SITE PLAN REVIEW

9/13/21 Plan Commission Meeting

DJN Family Partnership / Enercon Industries Corporation

Village Planner Report

C-103 Grading Plan

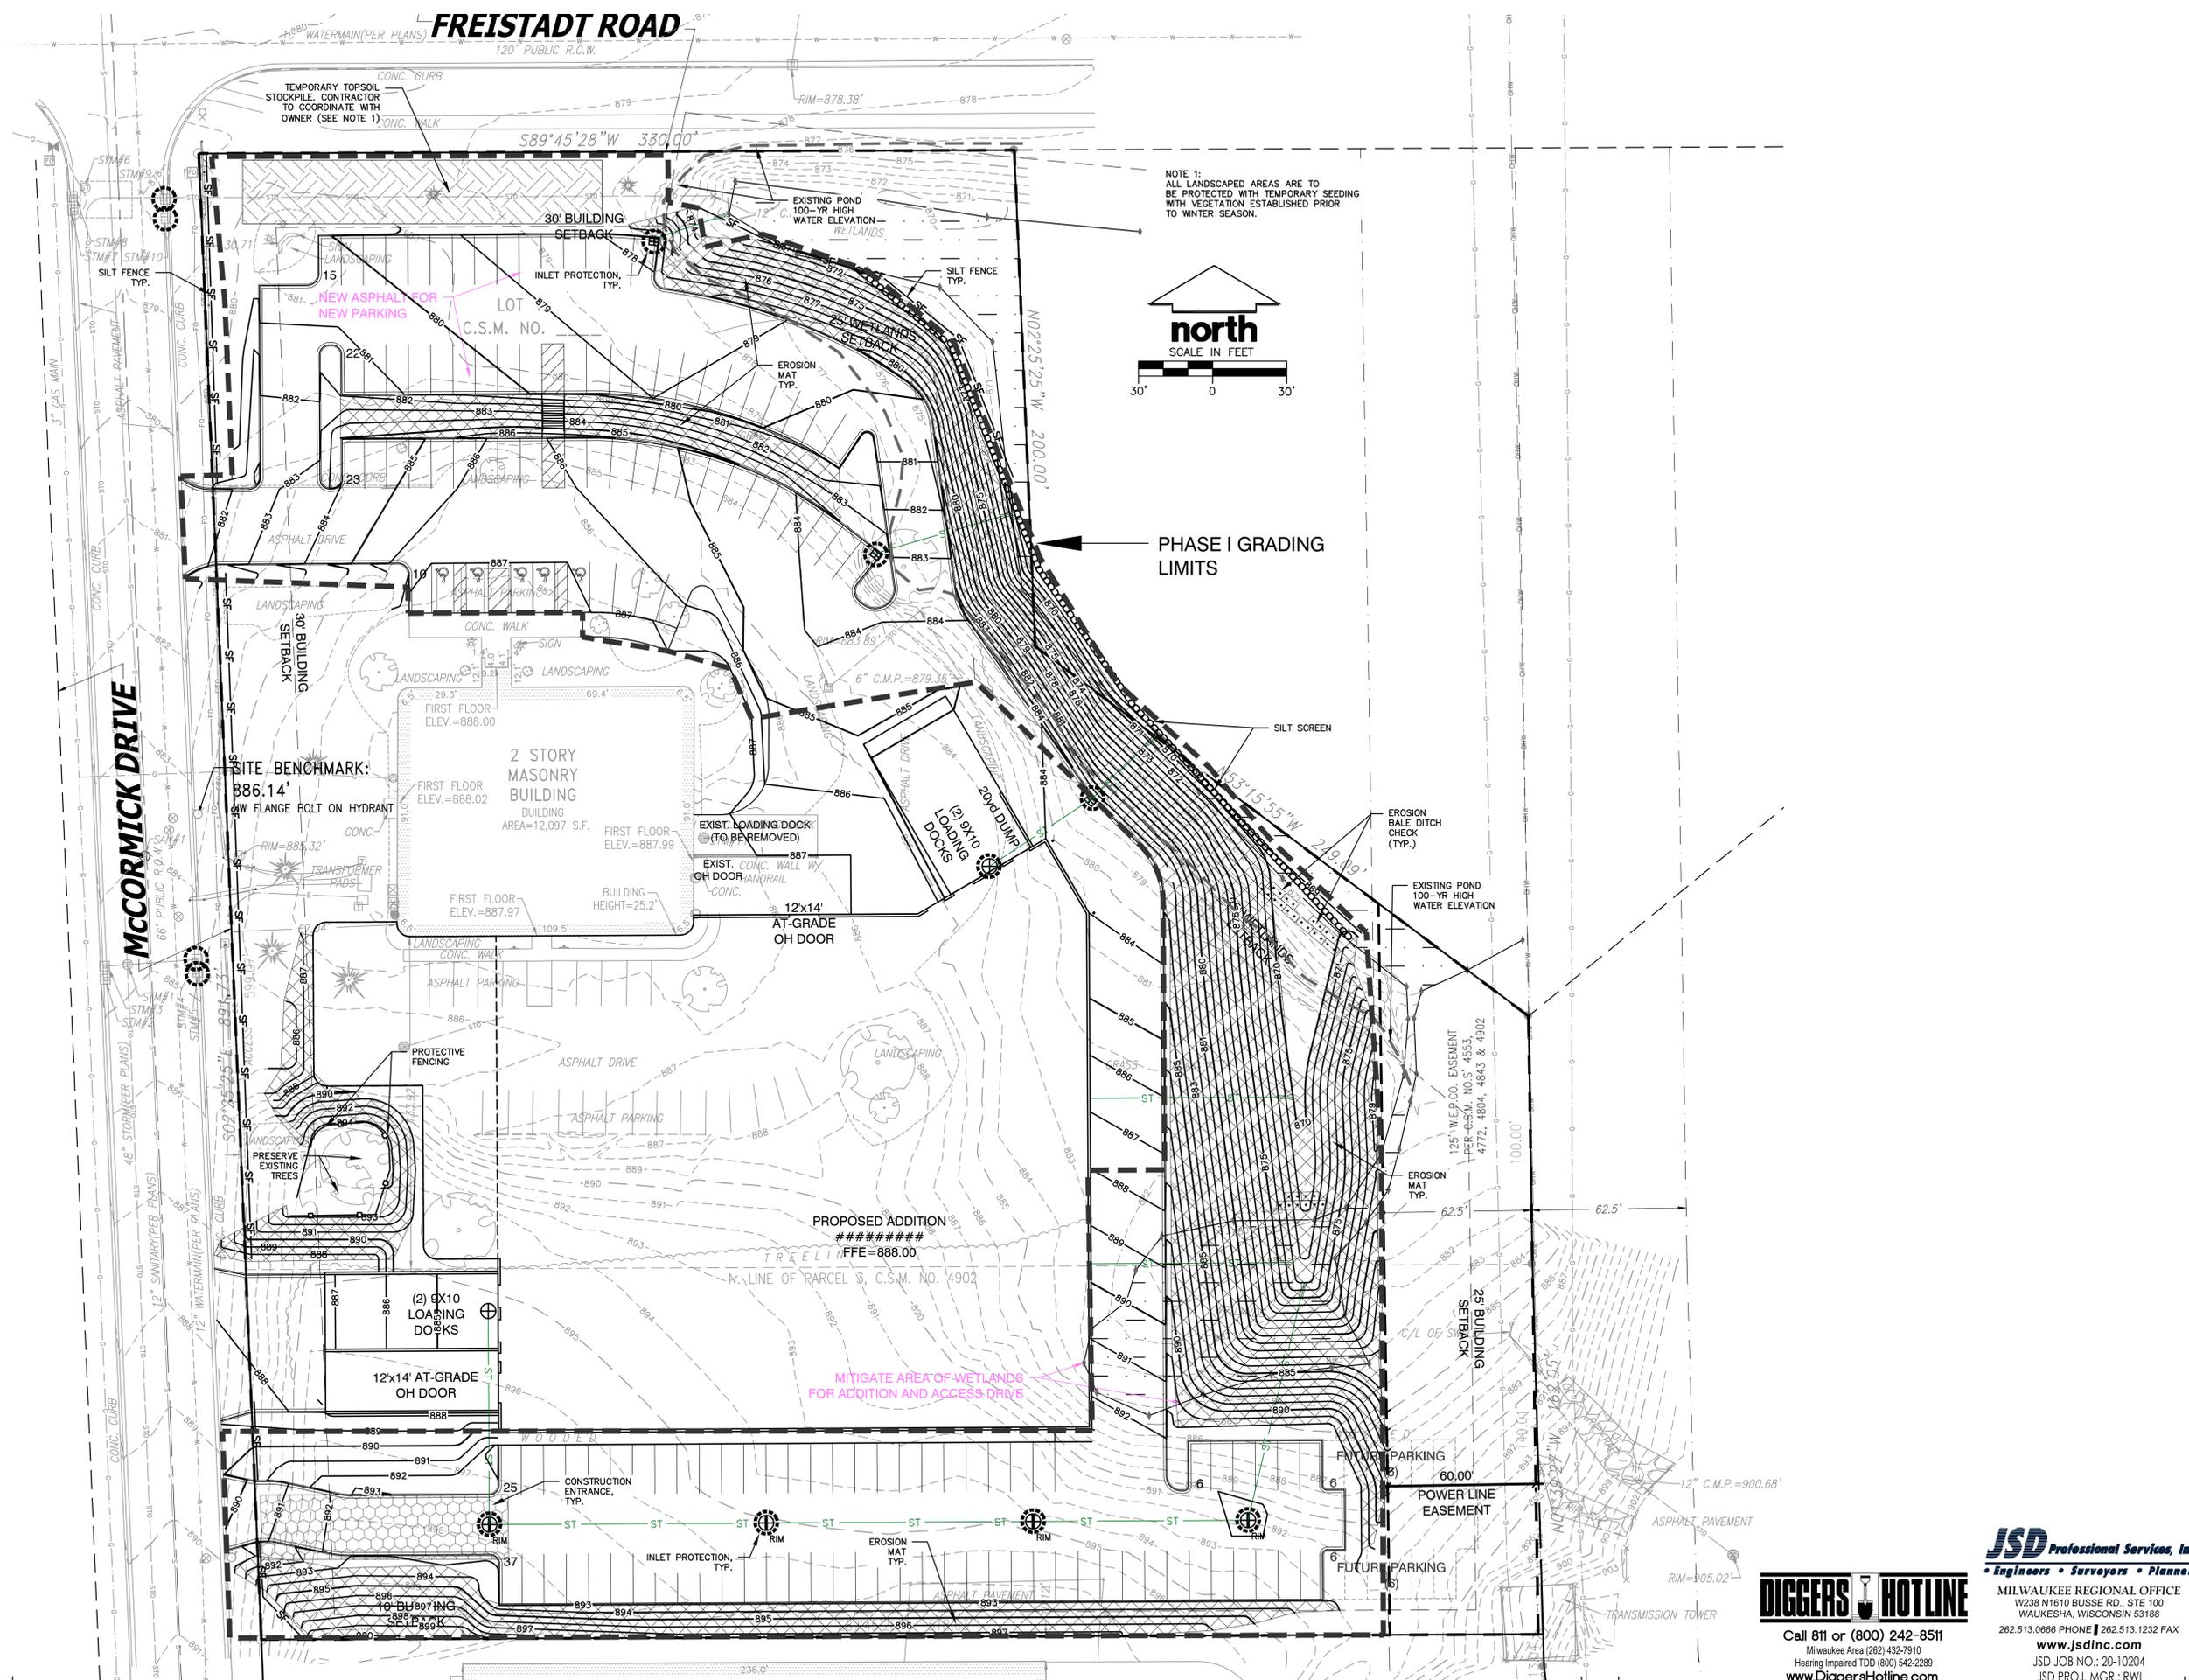
- 1 Show overflow route through the site with large bold arrows.
2. The proposed loading dock on McCormick Drive will drain a large area of pavement to the ROW. Install a trench drain at the ROW to collect this flow on-site.
3. Show limits of the future building on the plans. It's not clear where the building is on the west side of the site.
4. Grading shown around the existing trees to remain will be difficult to install correctly. Add additional notes and flow arrows indicate drainage intent.
5. Provide top and bottom of wall elevations for all retaining walls.
6. The letter provide with the submittal indicates this is planned as a phased project with the parking and driveways to be constructed now and the building at some point in the future. Show how the building pad will be graded in the interim condition.

C-104 Erosion Control Plan

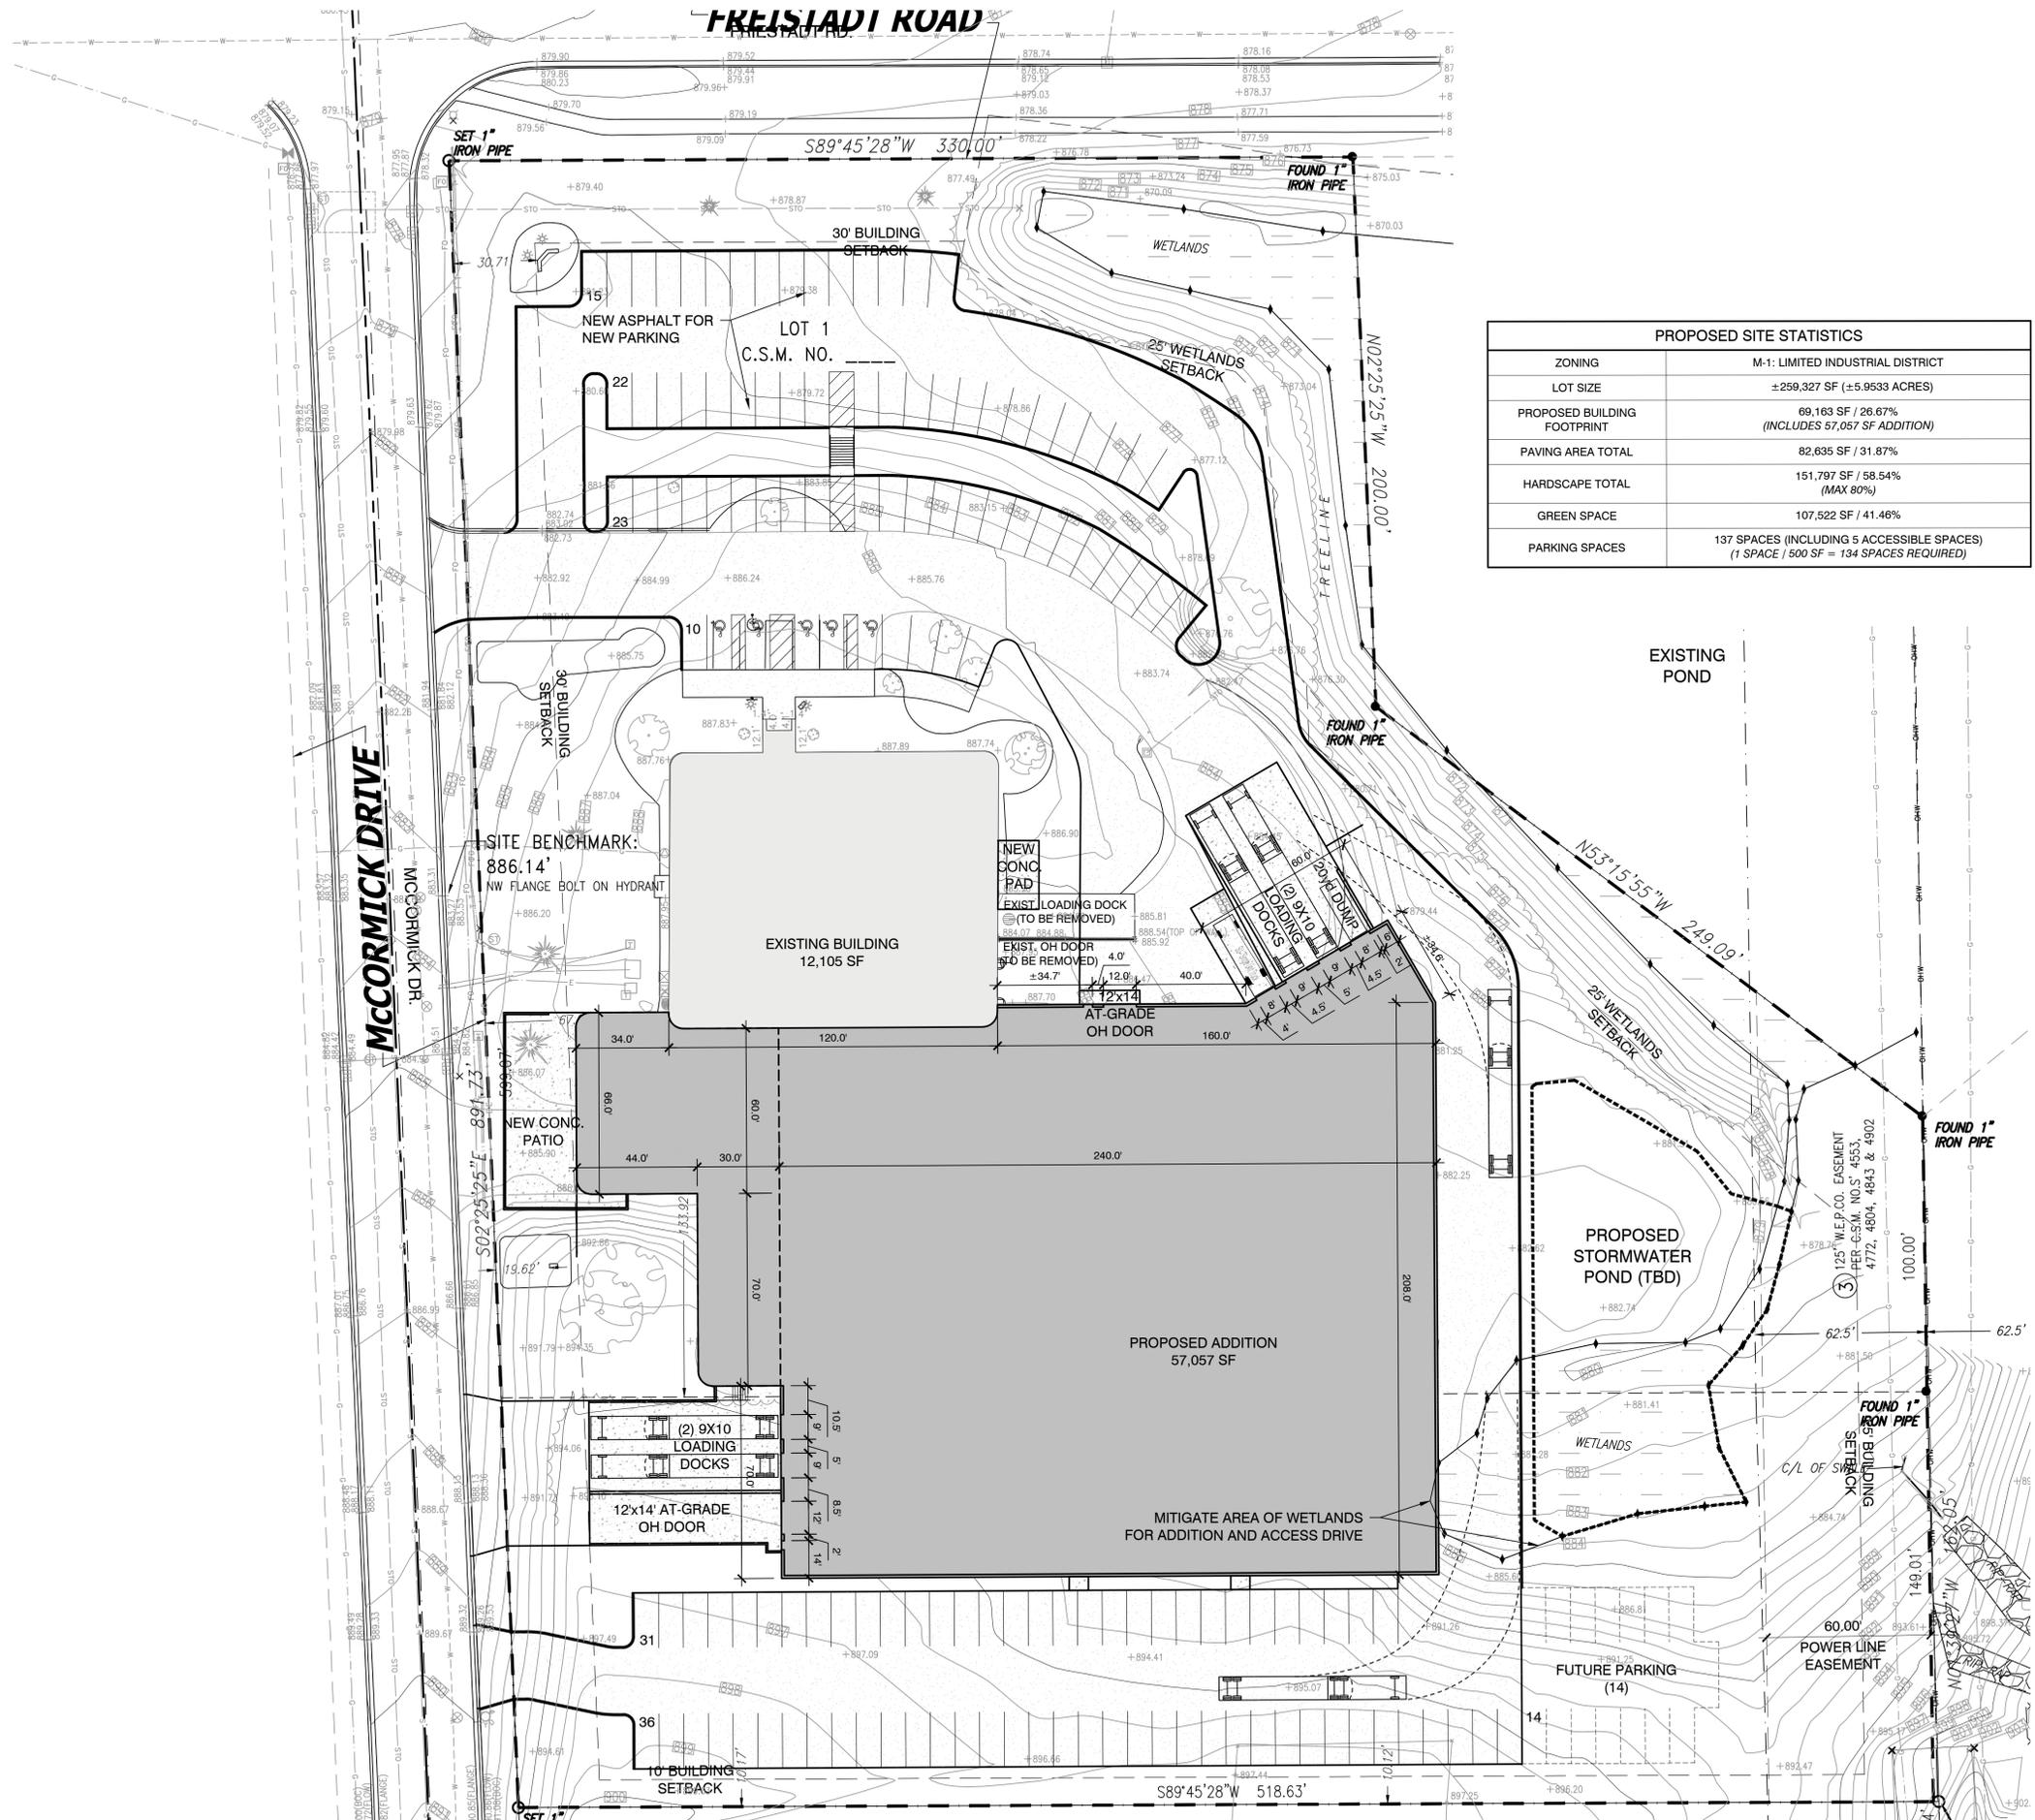
- 1 Provide an erosion control legend.
2. Provide typical erosion control notes, showing sequencing, inspection requirements, etc.
3. Provide late season stabilization requirements.
4. Provide additional information on the 'silt screen' shown on the plans.
5. Limits of silt fence is difficult to see. Please adjust the plan to clarify.
6. Provide on-site sediment traps to capture construction sediment before discharging to the Village stormwater basin. Size sediment traps per WDNR technical standards. Show how runoff will route to the basins.
